OPEN SPACE ADVISORY BOARD
Wednesday, June 8, 2011, 1:30 P.M.
8th Floor Conference Room
City Hall Building, 2 Civic Center Plaza

AGENDA

City of El Paso – City Plan Commission Staff Report

Case No: SUSU11-00042 Cimarron Sage Unit Three
Application Type: Major Preliminary
CPC Hearing Date: June 16, 2011
Staff Planner: Frank Delgado, (915) 541-4238, delgadofx@elpasotexas.gov
Location: South of Artcraft Road and West of Northern Pass Drive

ATTACHMENT 7

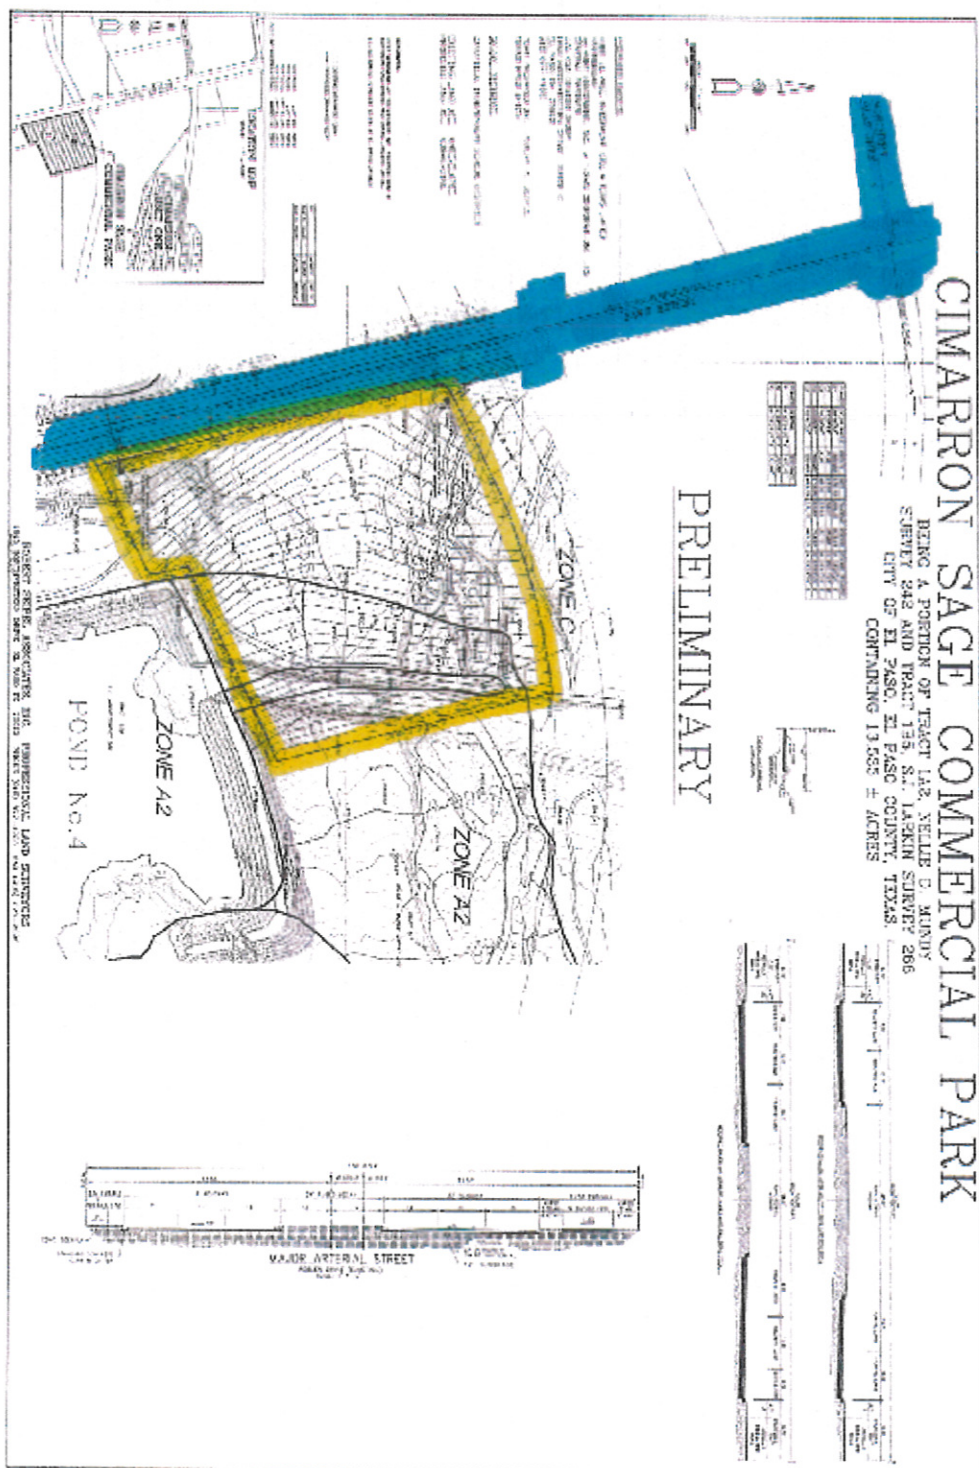
1. On the preliminary plat show all existing and proposed storm sewer and drainage structure locations.

2. The drainage plan for Paseo Del Norte Boulevard Unit 1 shows a 6'x 6' concrete box culvert proposed within the subject property just west of and parallel to the easterly property line. Show proposed culvert and provide a 30-foot wide drainage easement to accommodate the proposed concrete box culvert.

3. At the time of development, incorporate principles of low impact development and green infrastructure design (such as recessed landscaping, rainwater harvesting, and porous pavements) to reduce the amount of developed stormwater runoff. Provide additional stormwater retention at any common open spaces and landscaped areas.

4. The proposed development is located near a potential sediment debris source. (See the City of El Paso Stormwater Master Plan at epwu.org, Vol. 1 Section 4.0 and Vol. 2 Appendix C.) EPWU requires that the Engineer account for sediment volume in all calculations used to size stormwater drainage structures. Undersized culverts and culvert crossings in Northwest El Paso tend to clog easily and increase EPWU maintenance costs.

ATTACHMENT 2

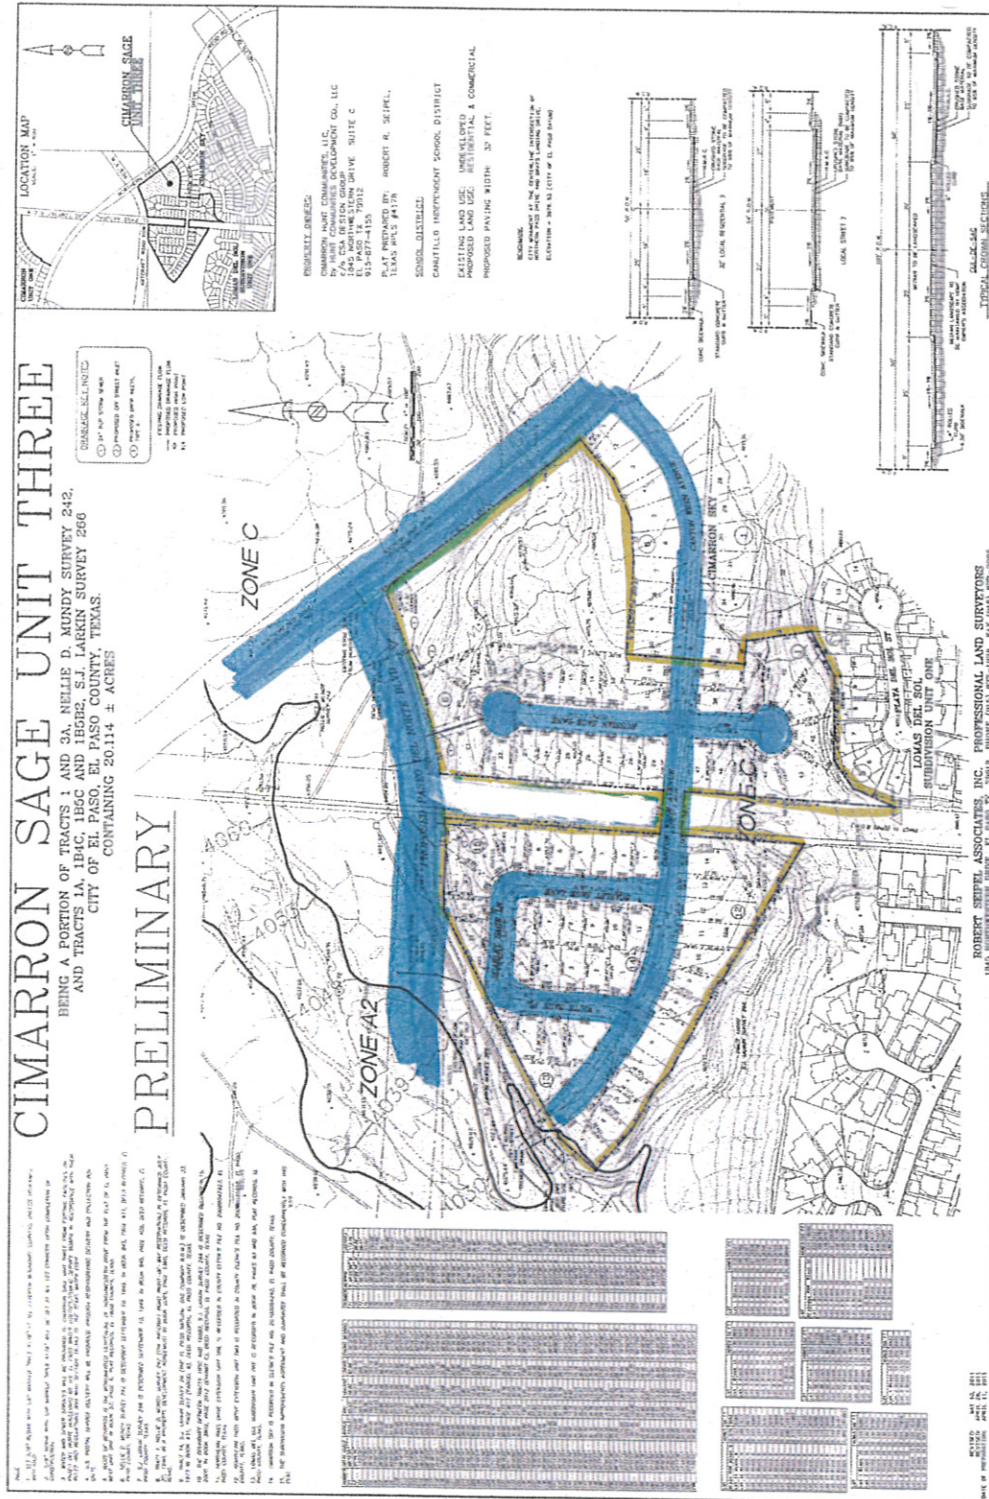
2. Label the width of the proposed Drainage R.O.W. between Lots 20 and 21 of Block 6.
3. Provide an adequately sized de-silting basin just upstream of the proposed off street drop inlet within Lot 30 of Block 6.

4. Surface drainage flow along the proposed streets must travel a long distance to enter the underground storm drain systems. EPWU may require extension of the underground storm drain systems upon review of the subdivision improvement plans.

5. Provide protection against local flooding within the EPNG R.O.W. on both the north and south side of Canyon Rim Ave.
6. An existing trench drain and an existing off street inlet are shown at the western terminus of Canyon Rim Ave. Confirm that these are future improvements and label appropriately.
